Service Bulletin

Product: EBZ7500, and 8500 Back Pack Blower models.

Text: Reference **SB# B1500048**
Time units (13 minutes): 7 units
Affected market(s): All markets

576561501 ---> 589266101

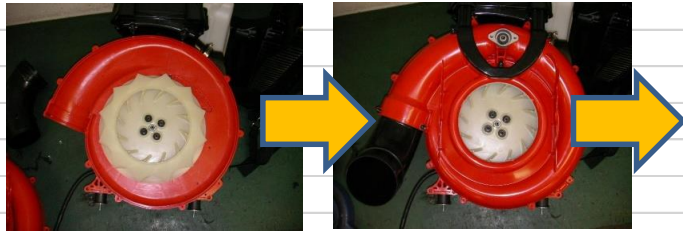
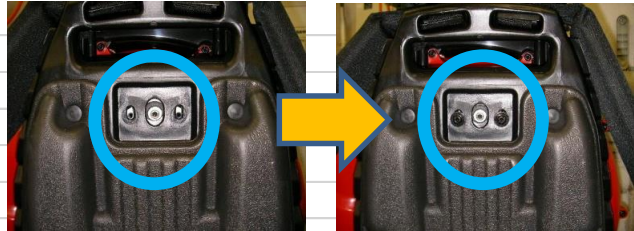
We have received reports of fan breakage on these backpack blowers. The 4-bolt sleeves of the fan/impeller could strip from the surrounding molded plastic of the fan/impeller assembly. An updated fan component to prevent stripping is now available.

13 Exchange the equipped fan to the new fan.

New fan part number: **589266101**

<p>14</p>	<p>Secure four screws for the fan.</p>  <p>Tightening torque ---> 12Nm</p>
<p>15</p>	<p>If needed, to chase two female threads on the upper damper and blow out.</p> 
<p>16</p>	<p>Secure twelve screws for the volute cover.</p>  <p>Tightening torque for ten screws ---> 3.5Nm Tightening torque for two screws around elbow ---> 1.0Nm</p>
<p>17</p>	<p>Put the unit onto the frame.</p>
<p>18</p>	<p>Secure two screws for the upper damper from back side.</p>  <p>Tightening torque ---> 3Nm</p>
